FIVE ESTUARIES OFFSHORE WIND FARM

10.20.1 TECHNICAL NOTE:
METHODOLOGY FOR DETERMINING MDS
(OFFSHORE) (TRACKED)

Application Reference:	EN010115
Application Document Number:	10.20.1
Revision:	<u>BA</u>
Pursuant to:	Deadline <u>42</u>
EcoDoc Number:	005395492-0 <u>24</u>
Date:	<u>October-December</u> 2024

Figure 1 Offshore cable crossings

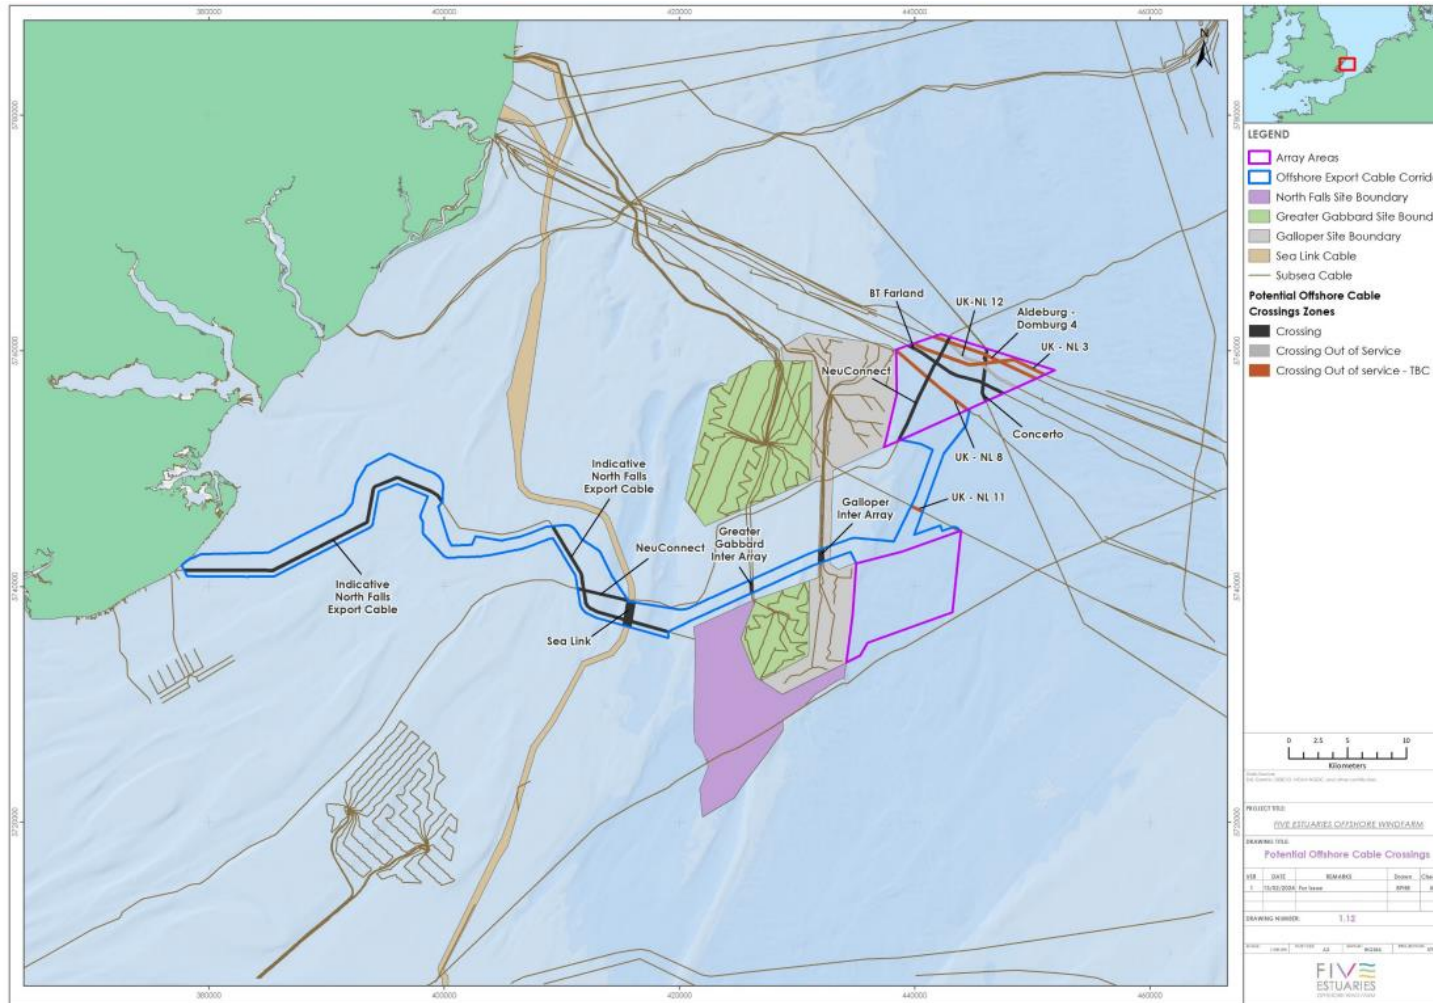
<p>b) Paragraph 2.1.3 restates that the maximum number of cable crossings has been set at 56. The Applicant must present a detailed explanation of how this parameter has been established, including any assumptions made.</p>	<p>Further details are provided in Section 2.12.1.</p>
<p>c) Paragraph 2.2.2 refers to the potential for a very small volume of sediment being trapped within rock voids and/or accumulating on the updrift side of berms of the cable protection, if required. The Applicant is requested to quantify the volume or provide an estimate of the maximum expected volume of such sediment.</p>	<p>An estimate of the volume of trapped sediment has been provided in Section 2.22.2. Context for this volume is provided in relation to the tip of the Margate and Long Sands (MLS SAC) sand bank which intersects the Export Cable Corridor (ECC). The relative volumes of potential trapped sediment and the tiny proportion of the nearby sandbank demonstrate that the potential effect of the project is not material.</p>

2.1.4 Figure 1 has been extracted from the Offshore Project Description APP-069. It can be seen that there are a number of planned, active, inactive / out of service (OoS) cables in the Export and Array area. This has been further summarized in Table 2.

2.1.5 The project has allowance for 56 cable crossings. At least 14 of these are anticipated to be for the Export Cables in the Export Cable Corridor (ECC). This leaves 42 for the array areas. It is not possible to identify the number of crossings in the array area until the final layout and array routing has occurred, and this will not be done until after DCO award. Similarly there are a number of OoS cables where though it is assumed the preference is to but remove these, however this is not confirmed yet. This is why the project cannot confirm the total number of crossings and instead has to make an allowance based on a range of possible scenarios.

Figure 5 Assumed external protection trapezium. Please note that bottom width is stated as 9.7m as it has been rounded to 1 decimal place

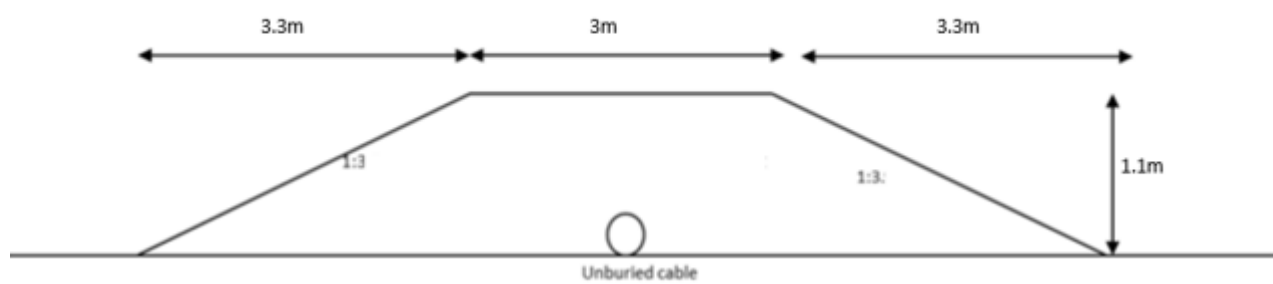
2.2.1 Within ExQ2 the question ME.2.05 the Examination Authority ExA has requested the Applicant to quantify the volume or provide an estimate of the maximum expected volume of such sediment the a very small volume of sediment that may be trapped within rock voids and/or accumulati ged on the updrift side of berms of the cable protection, (if required).

2.2.3 To calculate the volume of cable protection, the cross sectional area based on the above parameters is calculated, using the equation for the area of a trapezium:

$$6.99 = \frac{3 + 9.7}{2} 1.1$$

Hence the area for the trapezium is ~ 7m².

2.2.4 The area for the trapezium is therefore calculated as 7m² which can then be multiplied by the length of cable protection to provide the volume.

Figure 88 Historic bathymetry of the M&S shown on marine charts

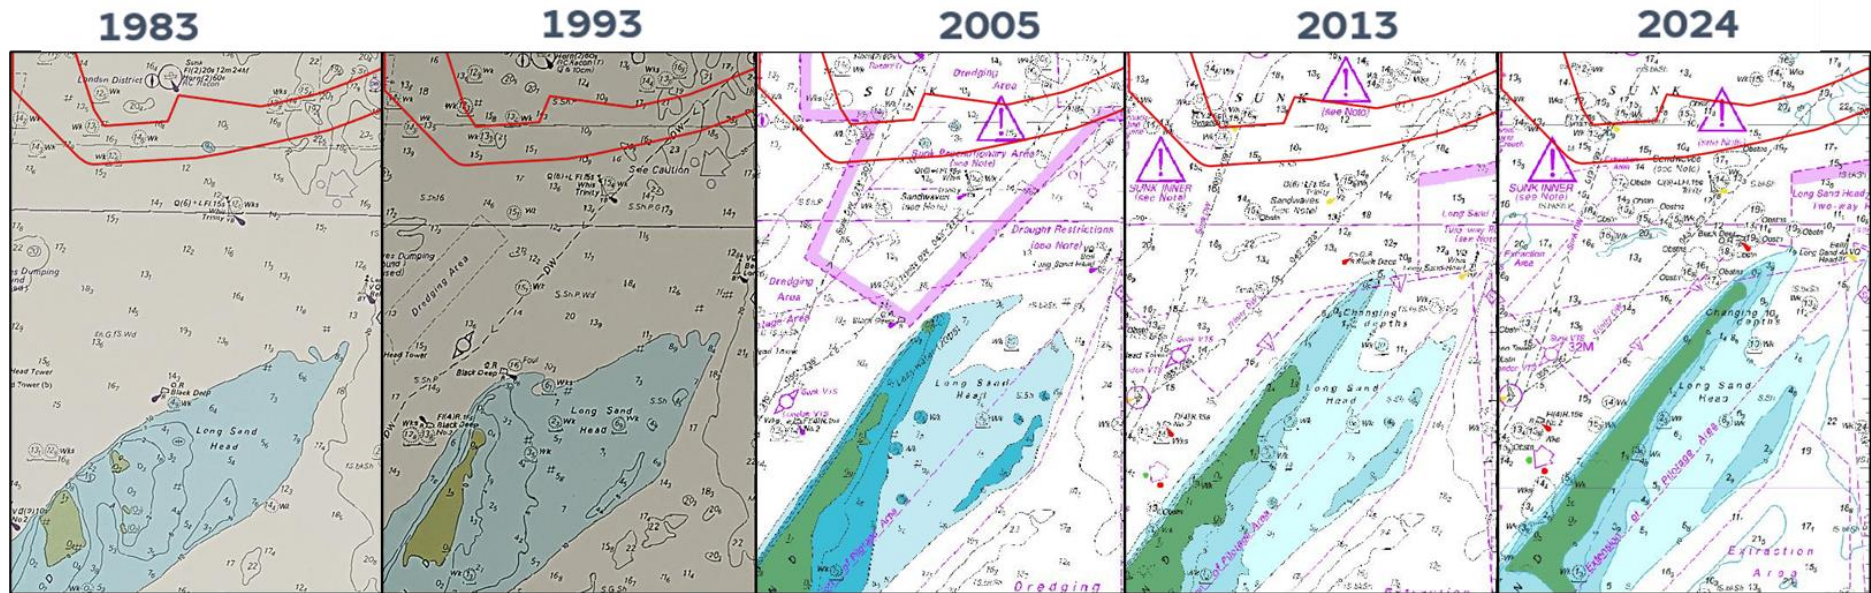
<p>d) Paragraph 2.2.4 states that monitoring and observation of operational offshore wind farms shows that large scale morphological features are not affected by the presence of</p>	<p>Covered in section 2.2.92.2.92.2.12 to 2.2.12.</p>

2.2.10 To support the assertion that the sand bank is controlled by processes that are orders of magnitude larger than the maximum impact of the project, the Applicant refers to the historic movement of the sand bank shown in Figure 88Figure 7 below.

2.2.11 The volume involved in this movement are in the order of magnitude of hundreds of millions of m³ of sand each decade.

2.2.12 The Applicant maintains the worst case rock berm installation of cable protection in the ECC and array areas combined in the proposed cable corridor isare many orders of magnitude too small to be likely to impact either the M&LS sand bank or the wider sediment transport processes in the areathis.

Figure 5 Maximum length of cable in SAC

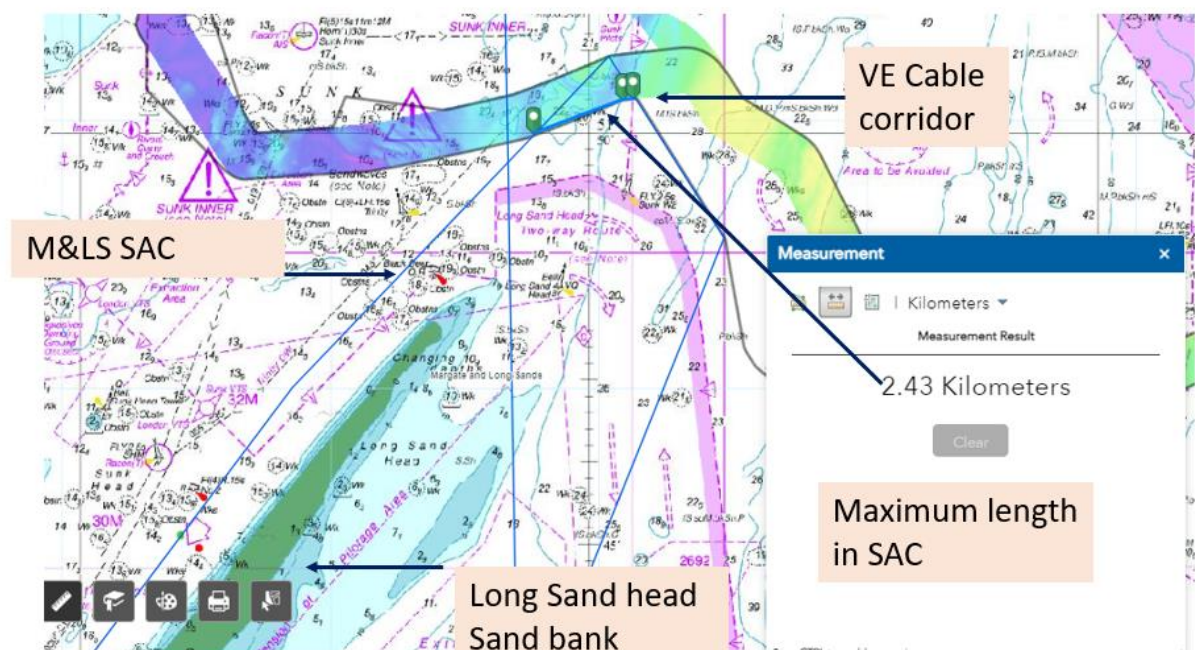
3.1 HOW HAS MAXIMUM LENGTH OF CABLE PROTECTION REQUIRED WITHIN MARGATE AND LONG SANDS (MLS) SPECIAL AREA OF CONSERVATION (SAC) BEEN DETERMINED?

3.1.1 Theoretical max single cable length is estimated at circa 2.5 km as shown in Figure 5 below. It can also be seen that the Long Sand Head sand bank feature is 4-5km from the cable corridor and separated by the Long Sand Head two way route (Shipping Lane) used by vessels transiting to the ports.

- 3.1.2 This would be hugging the southern corridor edge. The project cannot conduct the final routing until post DCO, however the Applicant has committed to the following *“Final cable routing will seek to take the shortest route through the M&LS SAC where possible”* (9.13 Margate and Long Sands SAC Benthic Mitigation Plan [APP-243 Table 9.1]).

- 3.1.3 In practice this means this will mean that during detailed routing weighting is applied to minimising the length of the cable routes in the SAC. This is then balanced against other constraints such as minimising the time in the vicinity of the sunk pilot diamond to the north to avoid shipping & navigation impacts for the ports, physical constraints on the seabed such as UXO or archaeological features, targeting preferred geology for cable burial, avoiding sand waves etc.

- 3.1.4 Based on the preliminary work conducted to date this is resulting in indicative routes with between 0.4-1.5km within the SAC.

3.1.5 A highly conservative assumption of 50% of the cable would require protection has then been applied to an assumed routing of 900 m per cable in the SAC. This has been combined with an assumed mattress width of 6m to result in the 5,400 m². This value is considered highly conservative by the Applicant and the most likely scenario is that no external cable protection will be used.
